RE: Murphy's Yard Redevelopment – Scoping Report Addendum

Project
 MURPHY'S YARD

Drawing Title
 Parameter Plan 01
 Location plan

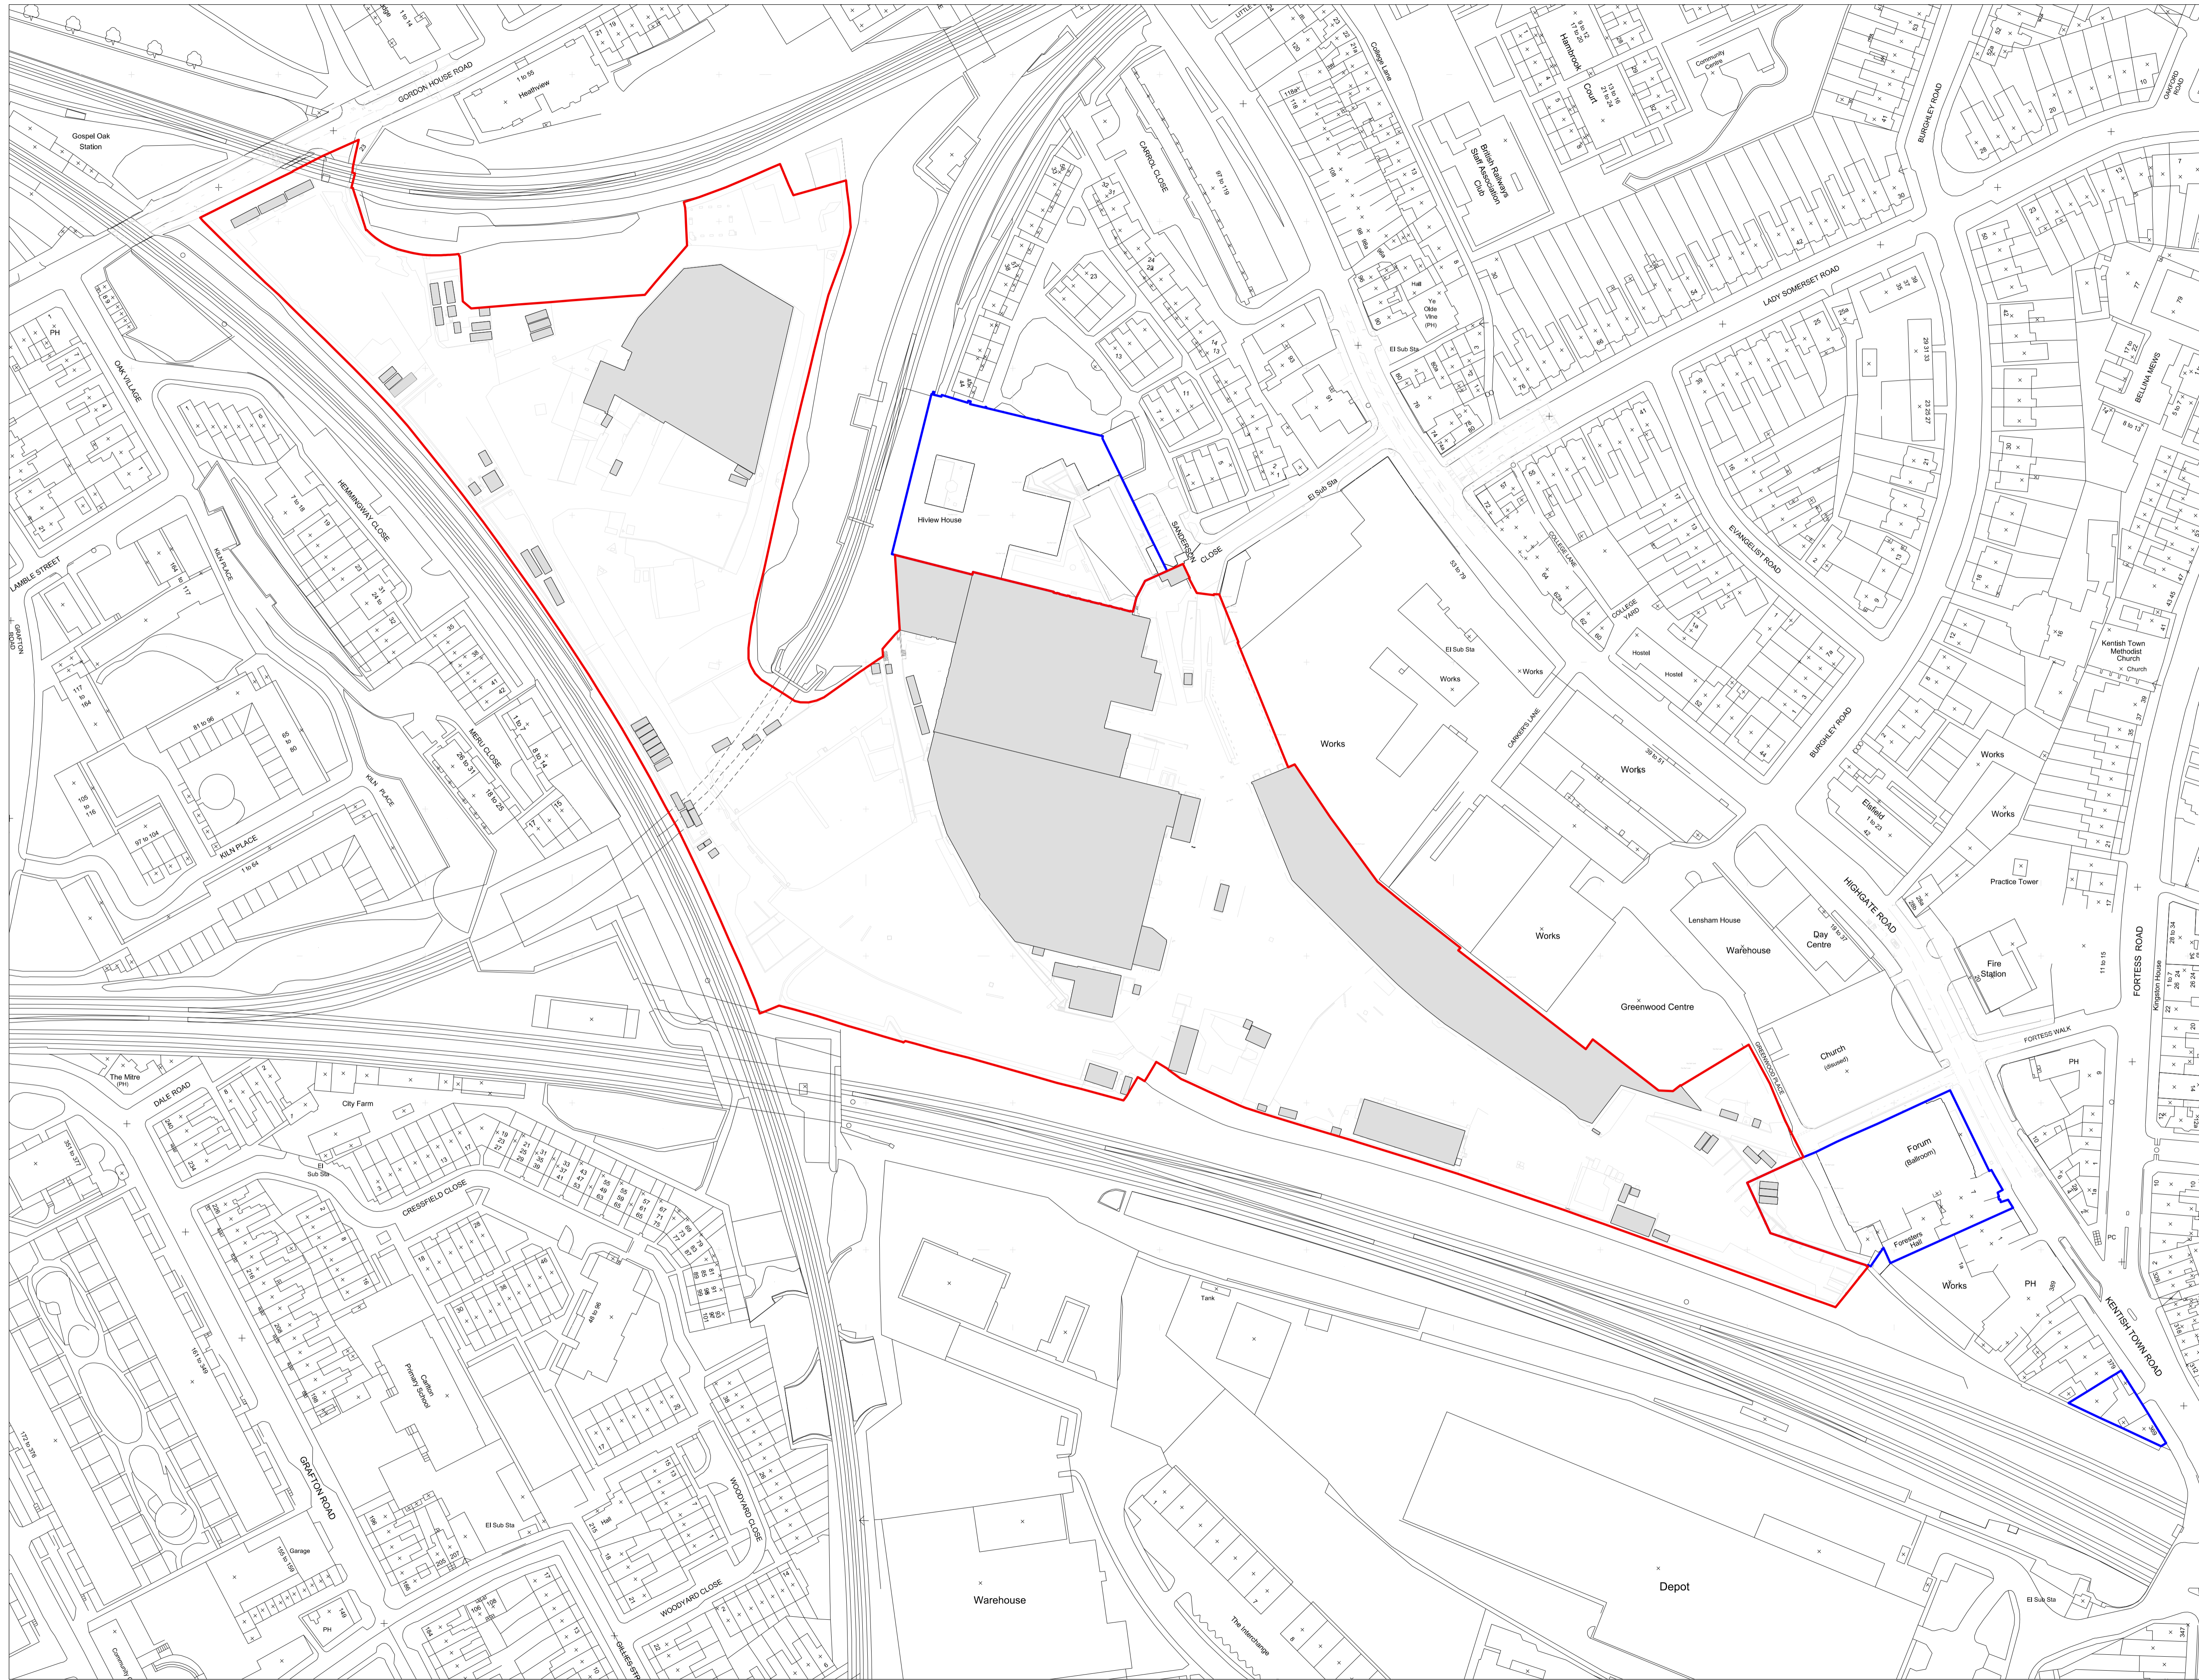
The redline planning application boundary is illustrated as Figure 2 of the December 2020 EIA Scoping Report (Page 2). The updated figure, provided overleaf, now excludes the Forum’s service yard.

The draft planning application boundary is represented in red, with any areas of additional land within the Applicant’s ownership in blue.
